Access Compliance Report

Public Rights-of-Way

(Curb Ramps)

Intersection ID: 50023	Main Street: SPRINGFIELD_GARDENS_DR	Cross Street: WYALONG_DR	Location: SE
ADA ID: 2E3D3356B165	Ramp Type: Perp	Initial Pass/Fail: Fail	Overall Compliance: No
Severity Score: 13.75			
Codes/Mitigation Info/Possible Solution		Field Measurements/Component Compliance

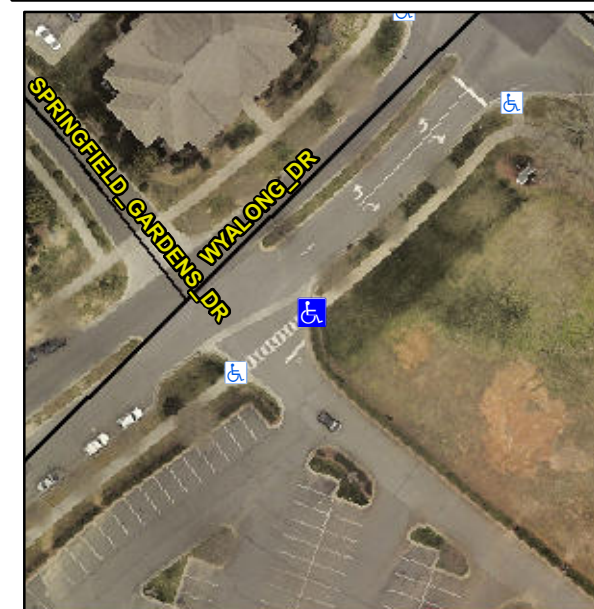
R304.2.2, R304.5.3

Compliance	Description	Data	Compliance	Description	Data
N/A	Ramp Length (in)	90.0	No	Ramp Slope (%)	8.5
Yes	Ramp Width (in)	57.0	No	Ramp XSlope (%)	3.4
N/A	Flare Type LT	N/A	N/A	Flare Type RT	N/A
N/A	Flare Slope LT (%)	N/A	N/A	Flare Slope RT (%)	N/A
N/A	Flare Traversable LT?	N/A	N/A	Flare Traversable RT?	N/A
N/A	Landing Length (in)	N/A	N/A	DWS Provided?	N/A
N/A	Landing Width (in)	N/A	N/A	DWS Contrast?	N/A
N/A	Landing Slope (%)	N/A	N/A	DWS Length (in)	N/A
N/A	Landing X Slope (%)	N/A	N/A	DWS Full Width?	N/A
N/A	Landing Curb? (Y/N)	N/A	N/A	DWS Offset (in)	N/A
N/A	Shared Landing?	N/A			
N/A	Gutter Ponding?	N/A	N/A	Gutter Slope (%)	N/A
N/A	Gutter Lip Ht (in)	N/A	N/A	Gutter X Slope (%)	N/A
N/A	Painted X Walk1?	Yes	N/A	Painted X Walk2?	N/A
	X Walk 1 Direction	To SW		X Walk 2 Direction	N/A
N/A	X Walk 1 Width (in)	72.0	N/A	X Walk 2 Width (in)	N/A
	X Walk 1 Slope (%)	0.5		X Walk 2 Slope (%)	N/A
	X Walk 1 X Slope (%)	0.2		X Walk 2 X Slope (%)	N/A

Remove & Replace Entire Ramp.
